Your ref
BN/114/21/PL

Our ref
PLAN-041566

Proposal: Creation of 1 No. 1.5 storey dwelling on brownfield (previous use commercial car parking / children's play area associated with holiday let business) (resubmission following BN/53/21/PL). This application is a Departure from the Development Plan & is in CIL Zone 3 & is CIL Liable as new dwelling.

Site: BN/114/21/PL: - Land to the rear of Highground House & Orchard End, Highground Lane, Barnham.

Southern Water MapGuide Browser

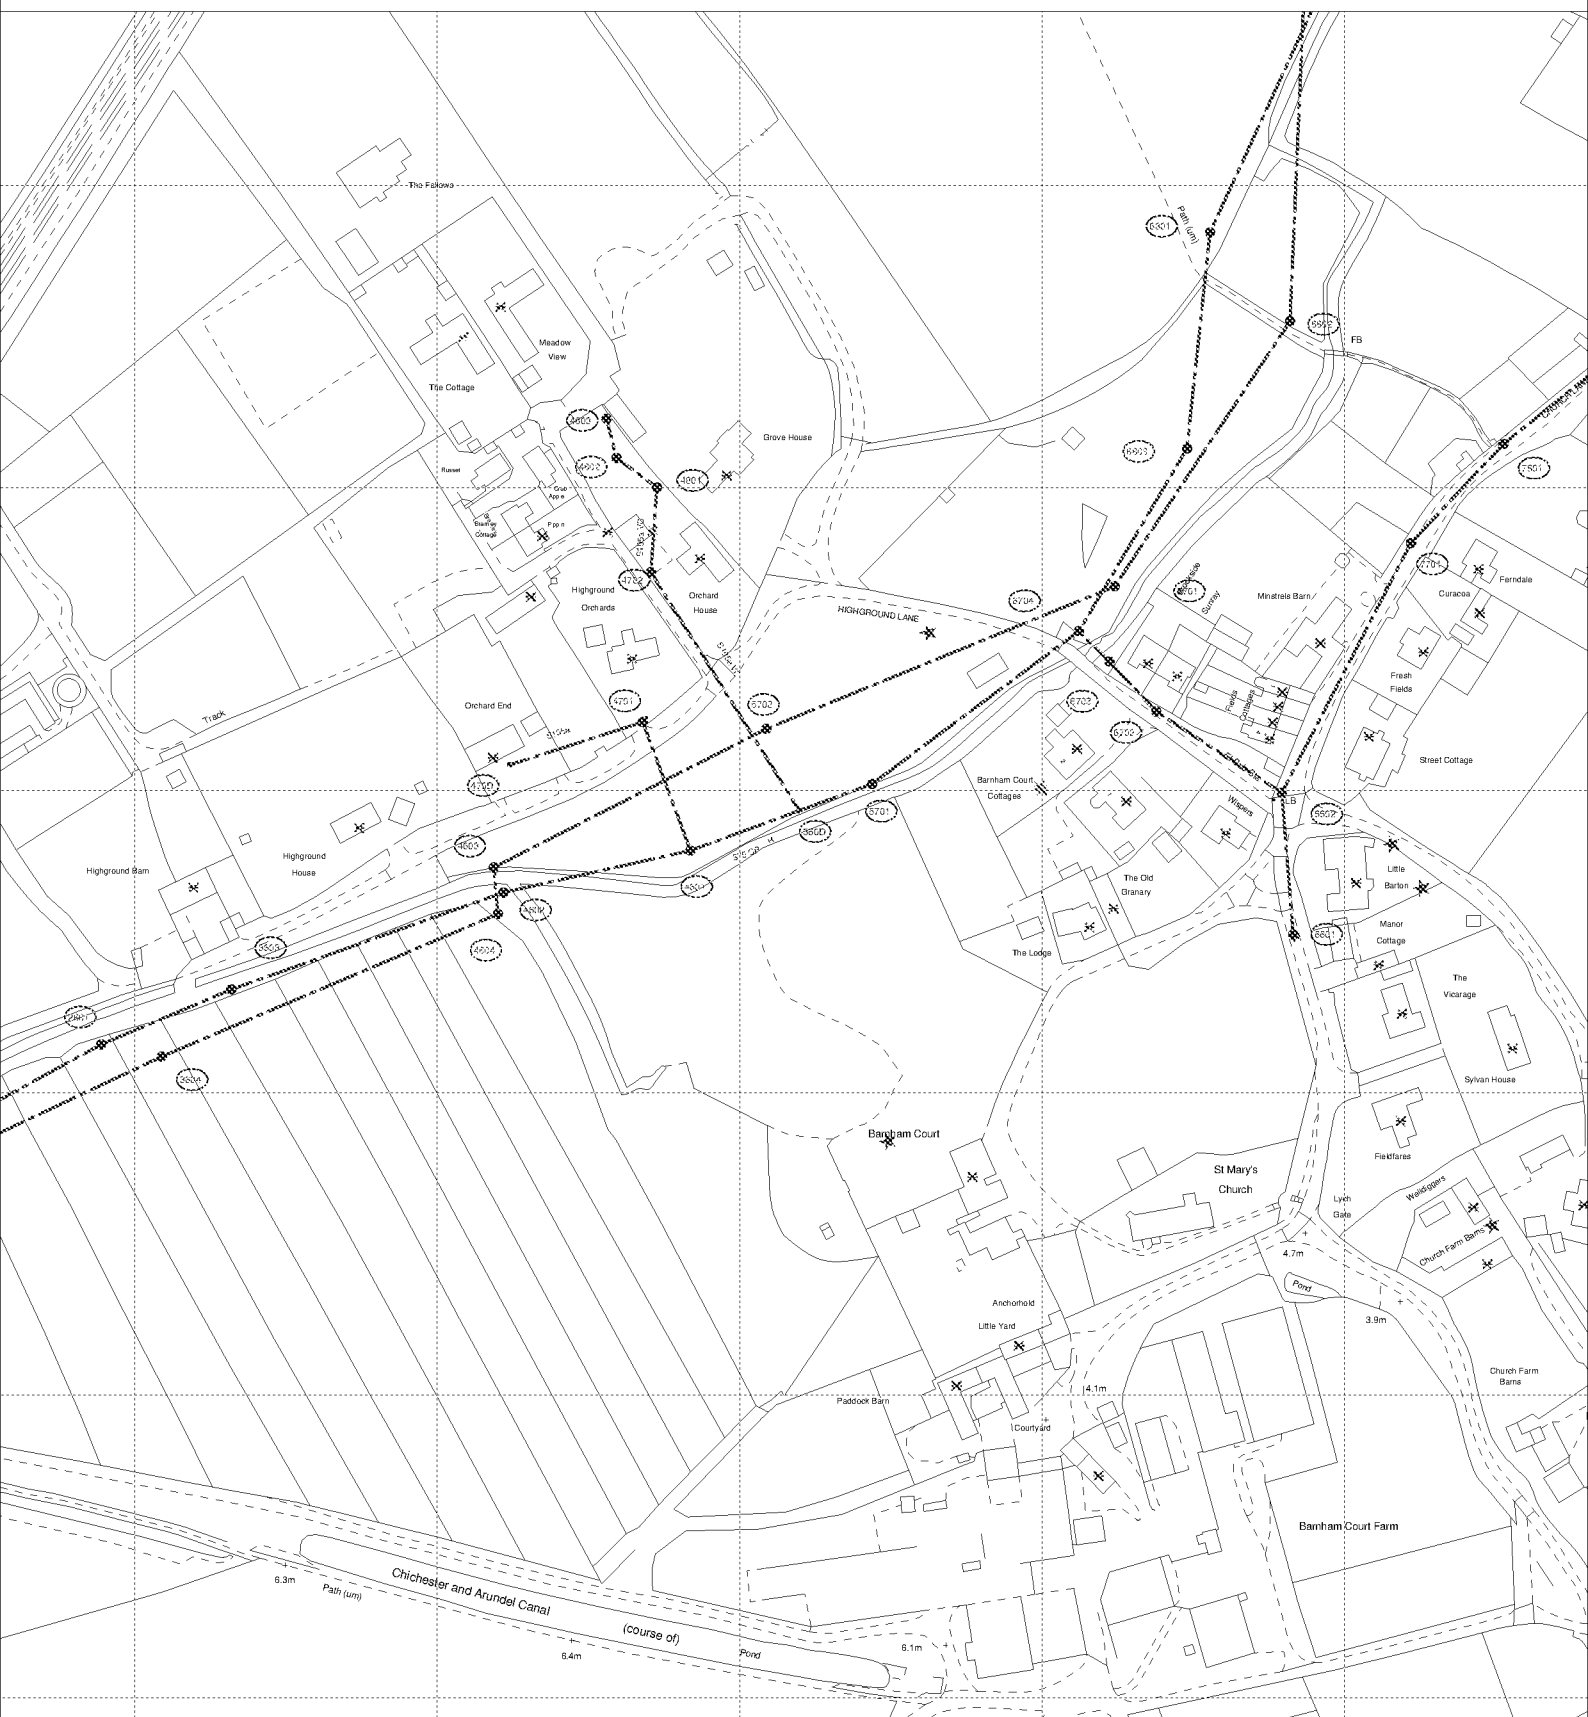
Please see the attached extract from Southern Water records showing the approximate position of our existing public foul sewer within the access of the development site. The exact position of the public assets must be determined on site by the applicant in consultation with Southern Water.

- The 350 mm public foul sewer requires a clearance of 3 metres on either side of the gravity sewers to protect it from construction works and to allow for future access for maintenance.
- No development or tree planting should be carried out within 3 metres of the external edge of the public gravity sewer without consent from Southern Water.
- No soakaway, swales, ponds, watercourses or any other surface water retaining or conveying features should be located within 5 metres of a public sewer.
- All existing infrastructure should be protected during the course of construction works.
